Service Information
No. SI-E4-016/1

SERVICE INFORMATION

Cylinder Head (CH) Identification – Alternative Methods

Fig. 1 Version 1 (old)

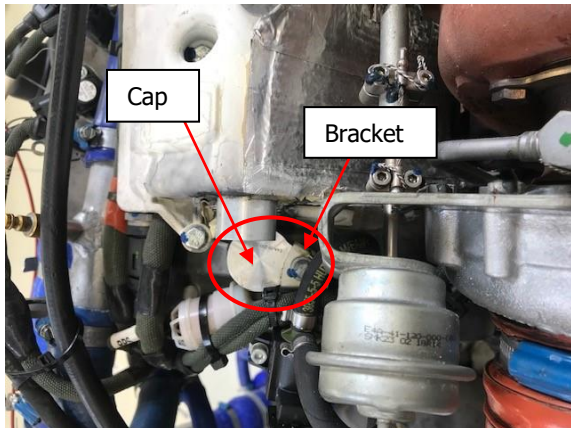
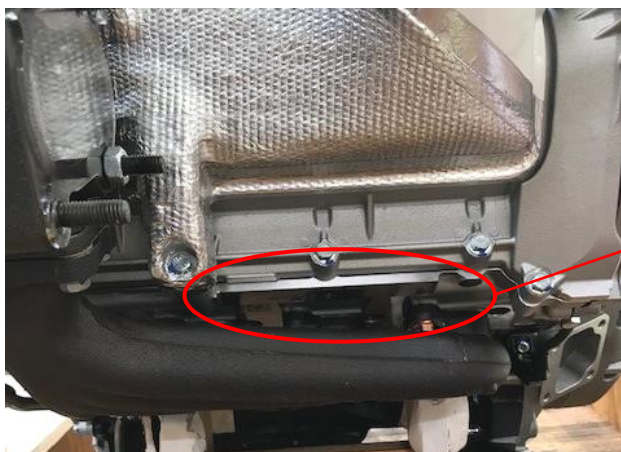
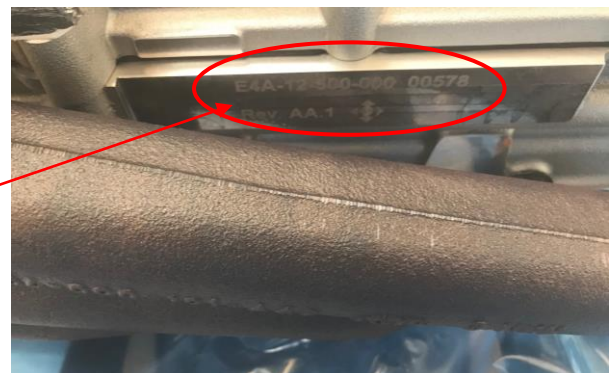
- I. The **old cylinder head** has a bore located at the wastegate side sealed with a cap (p/n E4A-16-200-301-000 engraved on the top of the cap). A bracket is installed where the boost pressure actuator is fixed. When the cap and the bracket are installed, the old cylinder head is installed. When the boost pressure actuator is directly mounted on the CH cover, the new cylinder head is installed.
